Certificate of Appropriateness for 1229 Jenifer Street

March 11, 2019

Proposed Work

Picture Window (added line where approximate location of Full Divided Lite Grille will go).

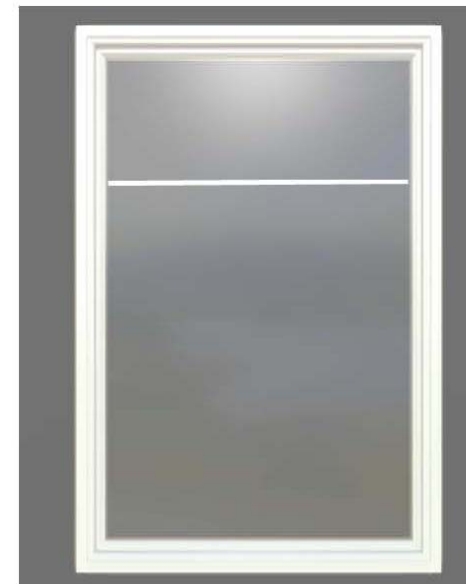
Staff has previously directed the applicant that they need to make a case that the windows are beyond repair, but also that distinctive windows (such as the large picture windows) should be retained in place.

Based on the materials submitted, staff believes that the standards for granting a Certificate of Appropriateness have not been met and recommends that the Landmarks Commission either deny this request or ask the applicant for additional information and refer to a future meeting.
